Rockwell- SERVICE BULLETIN

KWM-380 TRANSCEIVER (622-5093-001, -101) HF-380 TRANSCEIVER (622-3580-001, -101)

SERVICE BULLETIN NO 5

AUDIO AND RF GAIN CONTROL TAPER

KWM-380/HF-380 Front Panel, Rear View Figure 1

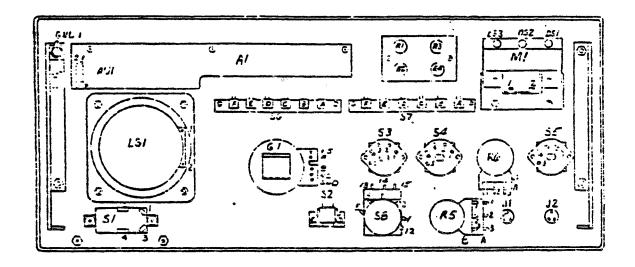
This modification replaces the original AF RF GAIN potentiometer with a new pot that has a more conventional taper (audio 10c log, rf linear).

NOTE: Refer to figure 1 while performing steps D through F.

- D. Remove R5 by removing one nut and one lockwasher.
- E. TAG AND REMOVE the wires connected to tandem potentiometer R5.
- F. Connect the wires that were removed in step E to the new R5.
- G. Install new potentiometer R5 (376-0276-050) using the nut and lockwasher supplied with the pot.
- H. Solder all electrical connections.
- Reinstall the AF RF GAIN knobs and tighten the setscrews in each knob.
- J. Reinstall the dust cover.
- K. Mark SB 5 on the service bulletin information chart. If the transceiver does not have an information chart, install a chart (280-3778-010) near the nameplate.
